ADDENDUM NO. 3 - Issued 09-03-2026
to the Project Manual and Drawings for

**JONESBORO FIELD OFFICE RECONSTRUCTION
ARKANSAS GAME AND FISH COMMISSION
JONESBORO, ARKANSAS
WDD JOB NO. 25-065**

25-065
JOB. NO.
07.30.2026
DATE
CD SET
ISSUE
A600

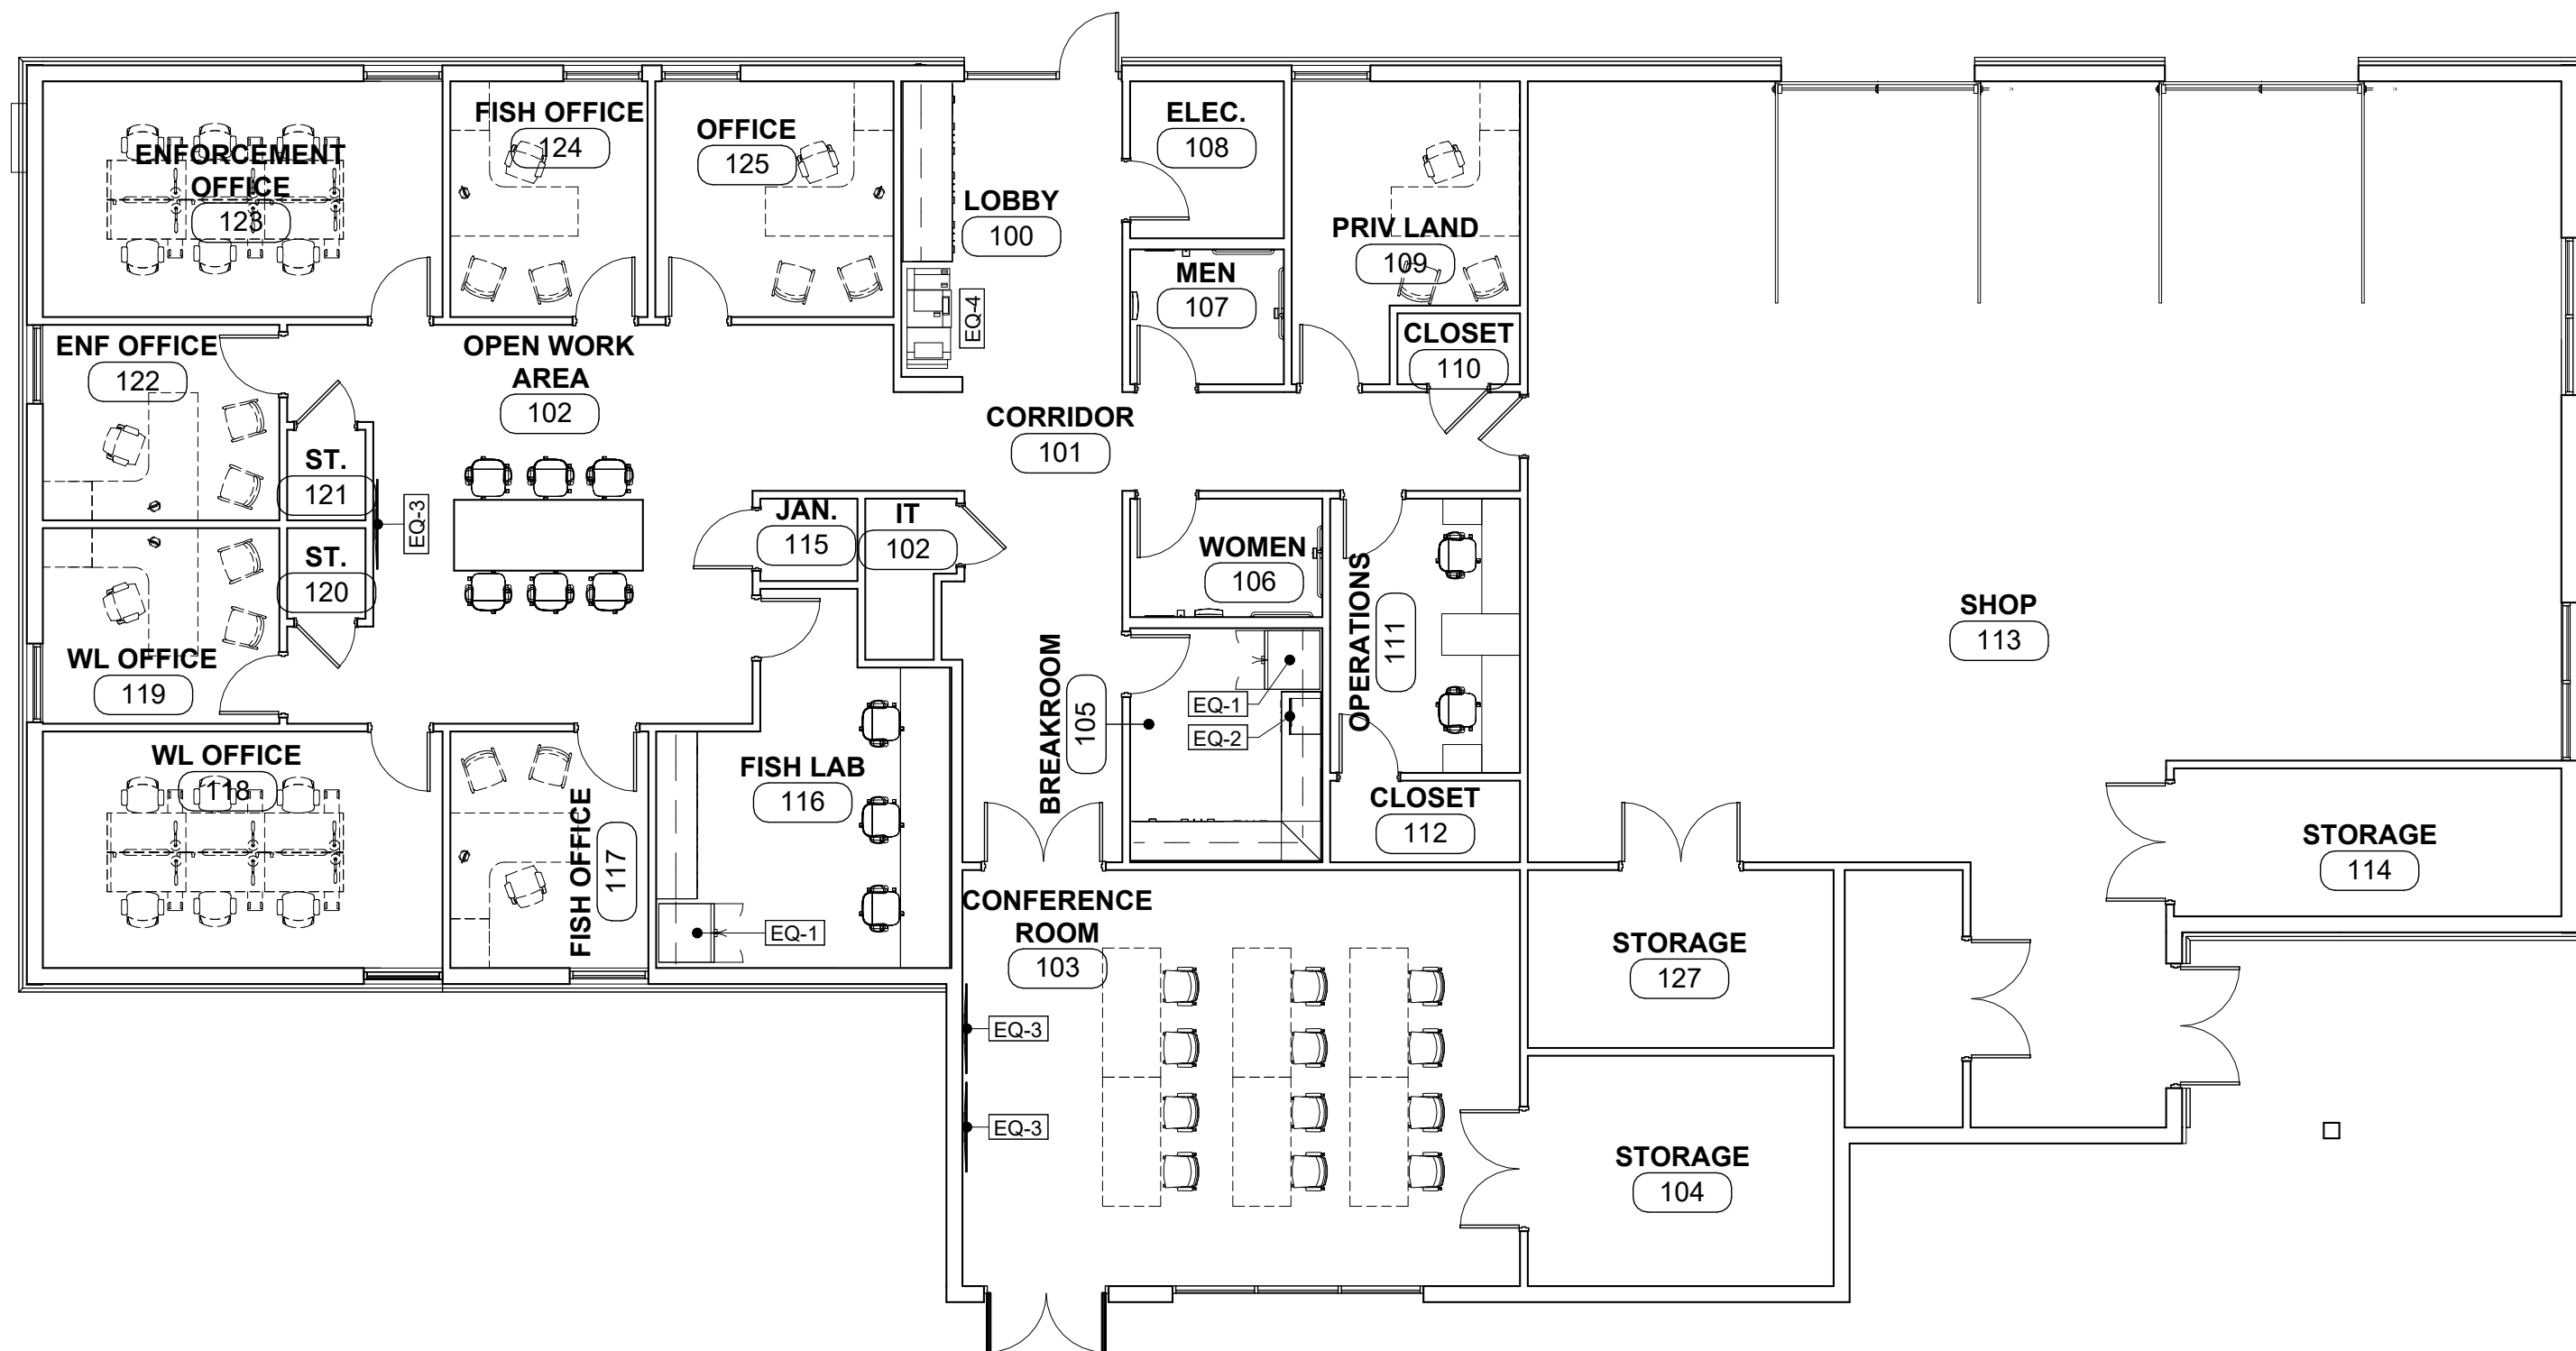
Sheet A600:

1. Flooring clarifications.

NO.	DATE	DESCRIPTION
1	9/3/2026	ADP#3 - FLOORING CLARIFICATION
